**5.2 NO. 188 (LOT: 1; D/P: 33790) VINCENT STREET, NORTH PERTH - PROPOSED ALTERATIONS AND ADDITIONS TO PLACE OF WORSHIP**

To consider an application for development approval for alterations and additions to the Redemptorist Monastery and Church at No. 188 Vincent Street, North Perth (the subject site).

MEZZANINE  
EXISTING PLAN  
SCALE: 1:100

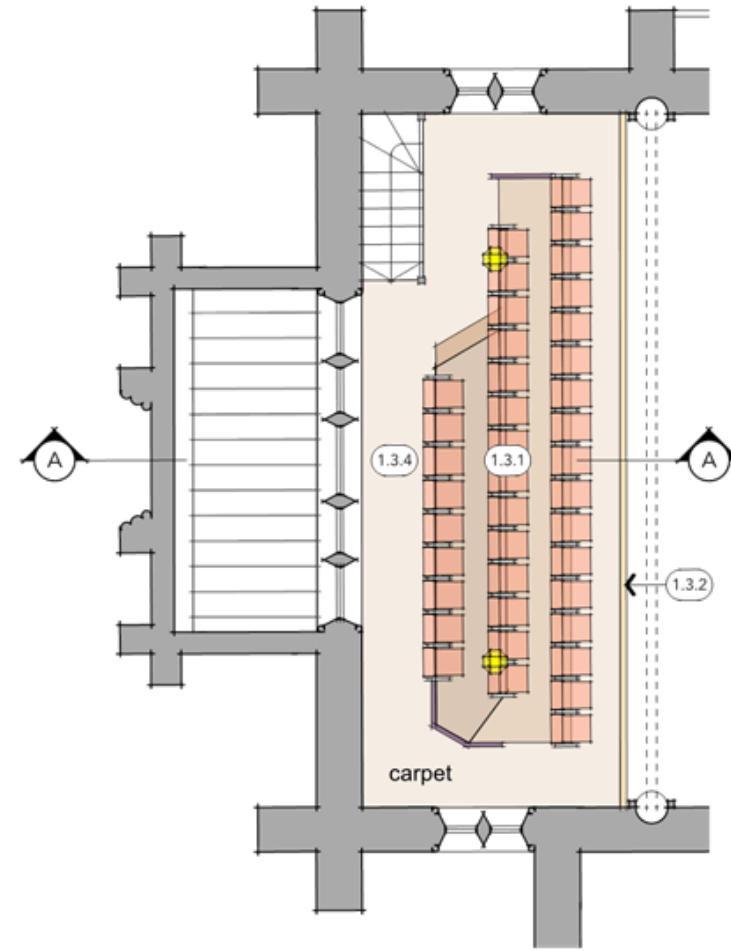
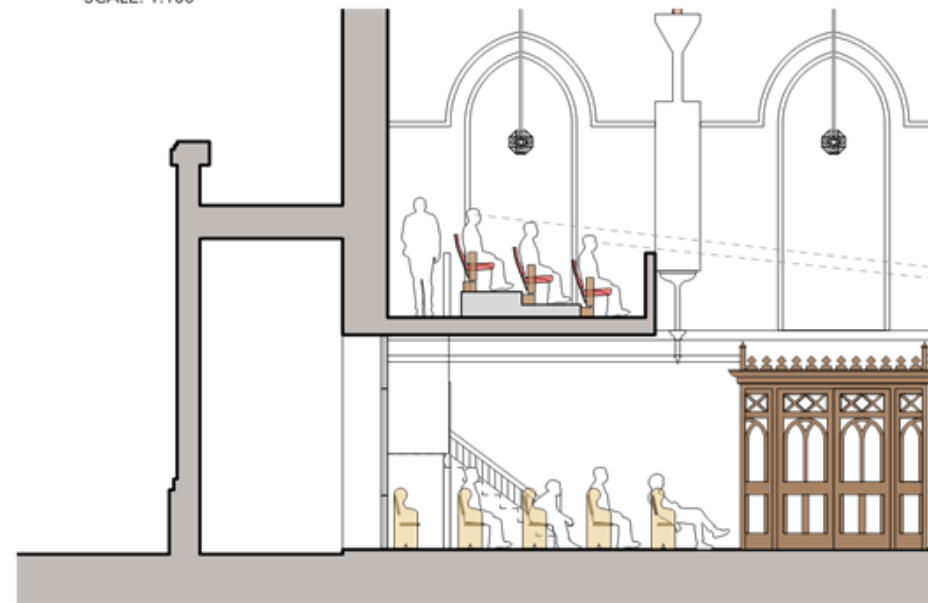
- Choir Gallery: The Choir Gallery is noted in the Conservation Plan as being in a fair – poor condition. The proposed works would improve the usability of the space by introducing a rake to the seating. Existing pews within the Choir Gallery would be retained and relocated on-site. The introduction of improved seating would contribute to the ongoing use of the Church for religious worship;

**NARTHEX  
WESTERN ENTRANCE PLAN  
SCALE: 1:100**

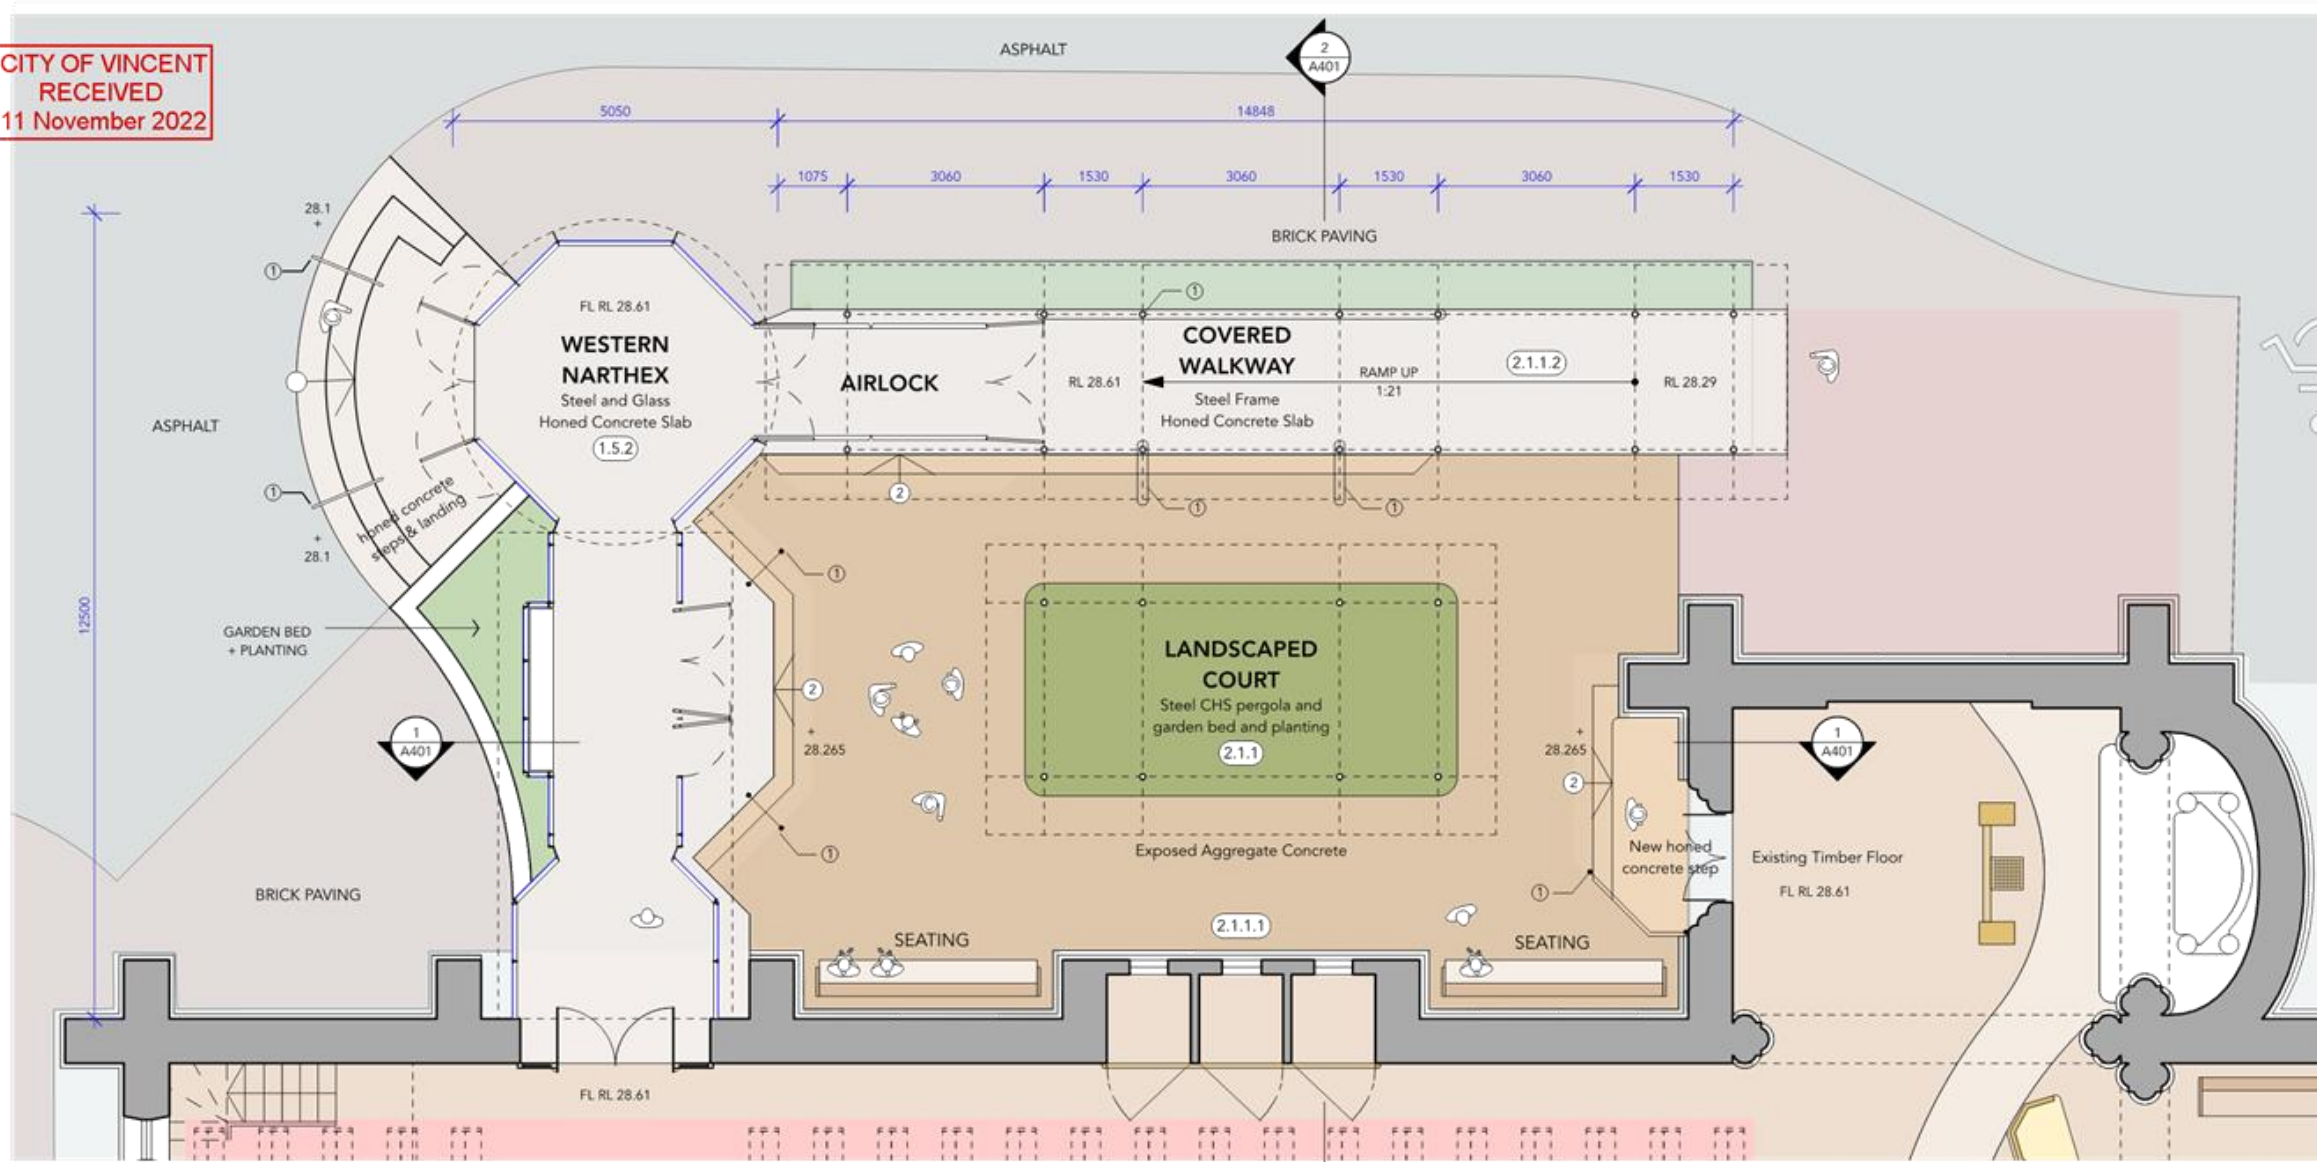
**3.2** The glazing to the covered walkway and Narthex shall provide a minimum of 70 percent visible light transmission to provide unobscured visibility;

- The proposed Narthex would be clearly identifiable as new work. It is a lightweight independent structure that would not impose on the Church. The copper domed roof would be in-keeping with transepts and is contemporary in design. The Narthex is designed in a manner that is sympathetic to the Church building and would not have a negative impact on the heritage values of Redemptorist Monastery and Church;

- The form and materiality of the Narthex would be sympathetic to the aesthetic heritage values of the Church. Steel, glass, and a standing seam copper roof combine to form a material palette that will be complementary to the Church materiality; and

**SANCTUARY**  
FLOOR PLAN  
SCALE 1:100

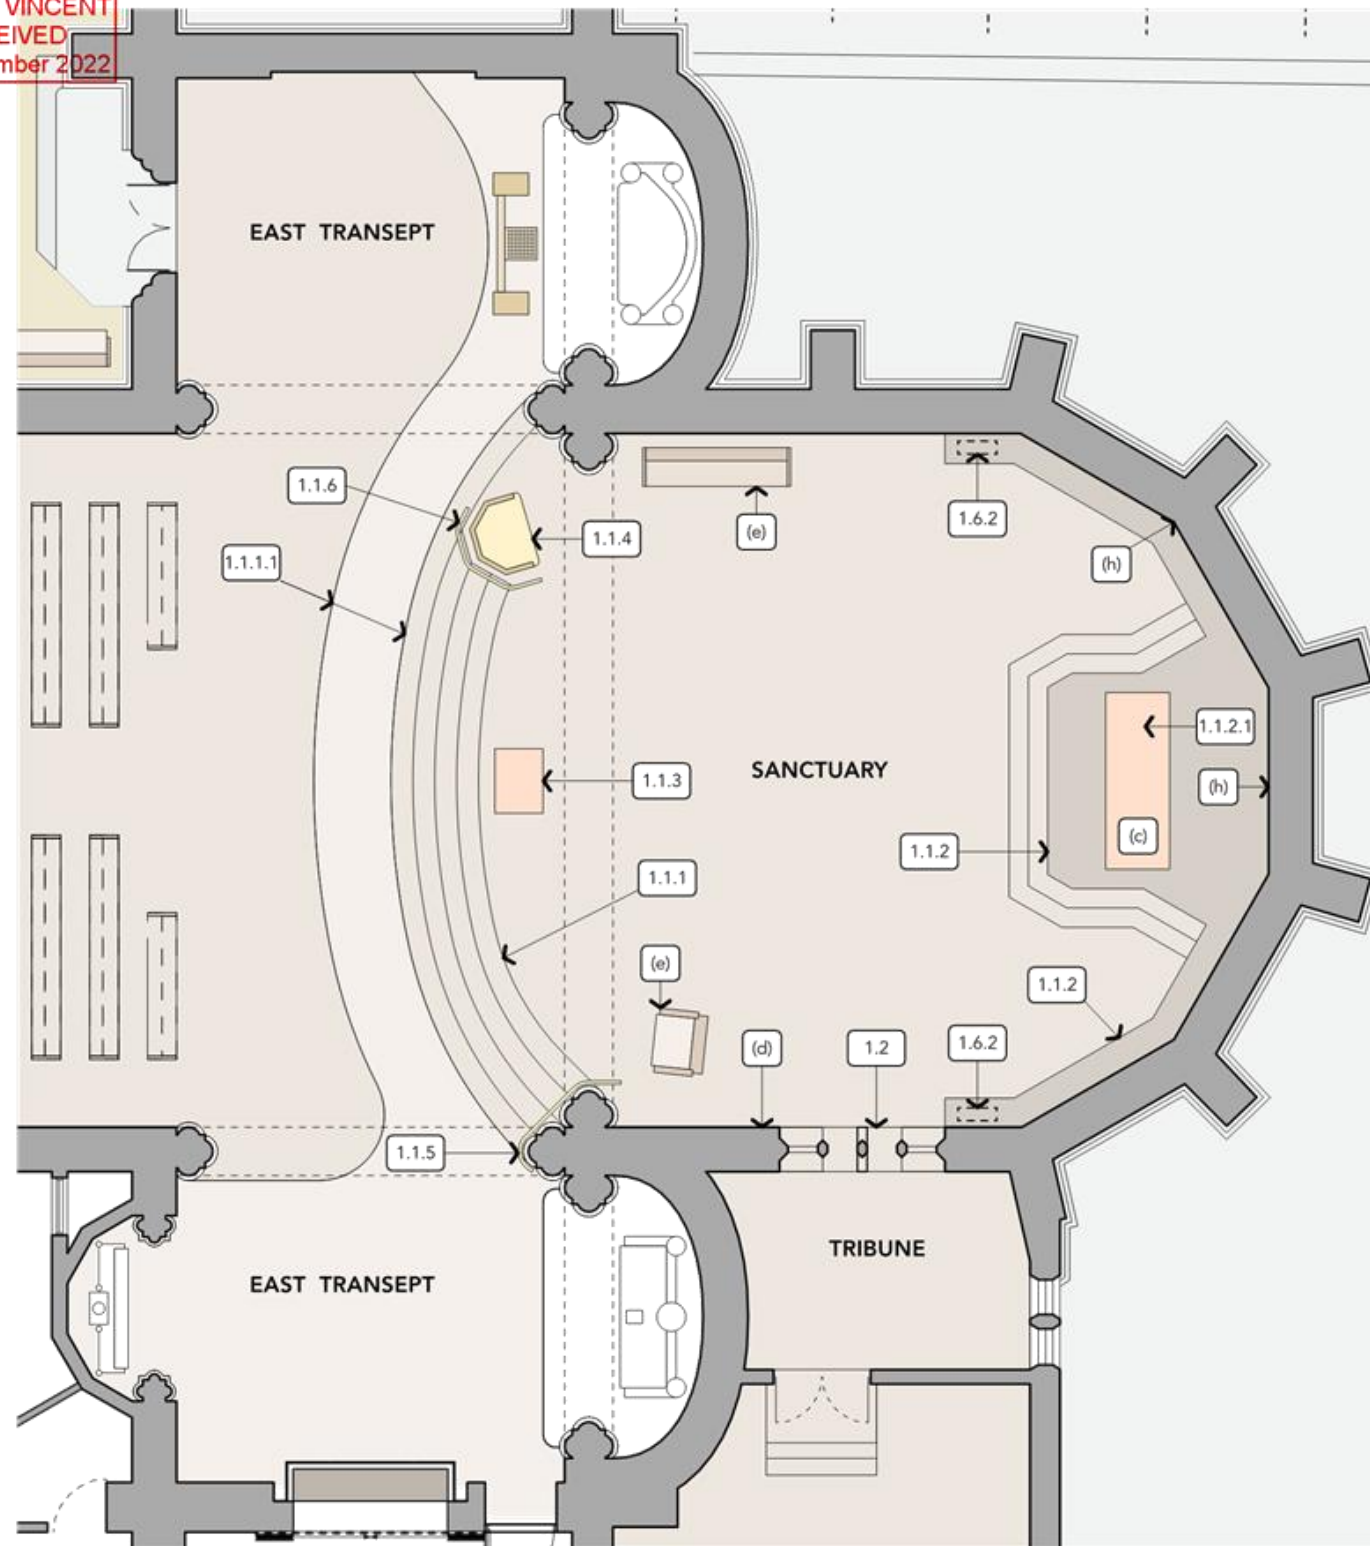
- The internal modification to extend the Sanctuary dais, modification of the Tribune screen and replacement of the seating would have minimal impact the heritage fabric of place. These works are all considered to fall within 73(3)(a) of the *Heritage Act 2018*;

- The proposed works to the Sanctuary, including expanding the dais, creating an alter podium with acolyte seating, relocation of the pulpit, and modifications to the mullions of Tribune tracery screen to enhance access are considerate of the Conservation Plan;

**EXISTING CONFESSIONAL DOORS & JOINERY  
ELEVATION**  
1:50

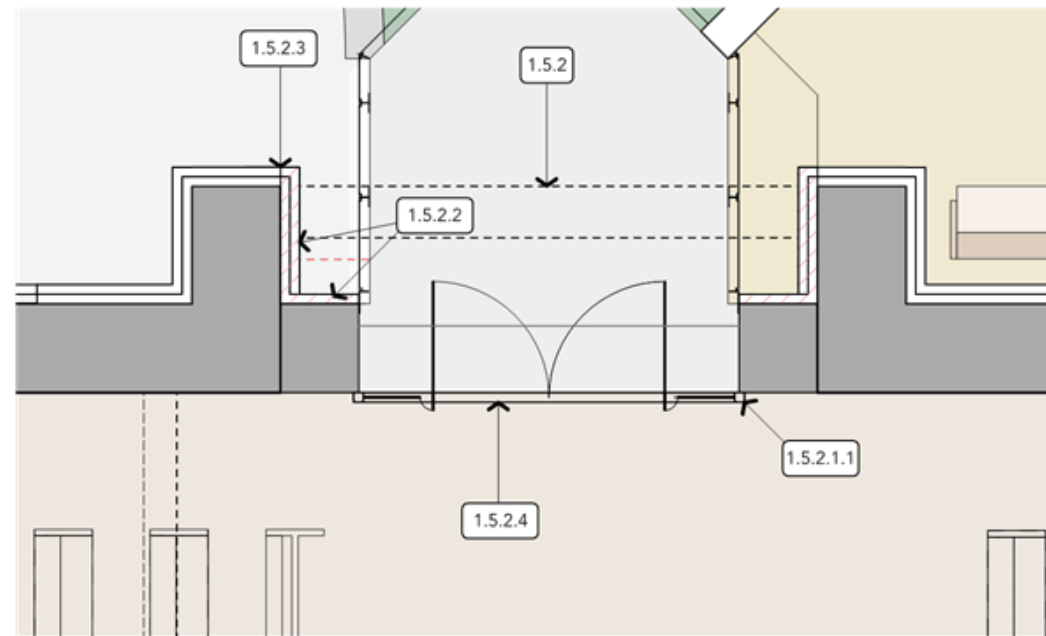
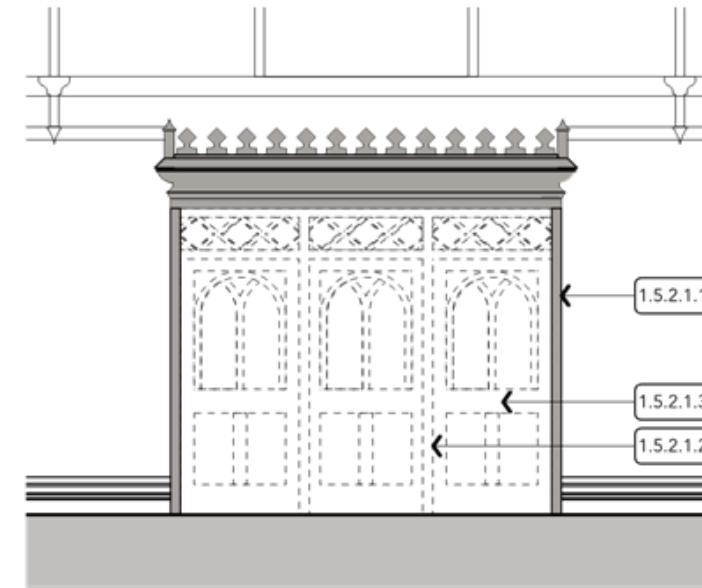
The deconstruction of the confessional and new openings to the Tribune Screen wall shall be undertaken with care. As much of the fabric as possible, including limestone should be retained for reuse, to the satisfaction of the City;

- The removal of the southern confessional on the western elevation would return that part of the building to an earlier state and would have minimal impact on the original heritage fabric of the Church;

- The removal of the confessionals and constructing a new western entrance would be sympathetic to the heritage fabric of the place and assist Church access. While views of the western façade would be impacted, this is considered acceptable due to the improved access benefits;
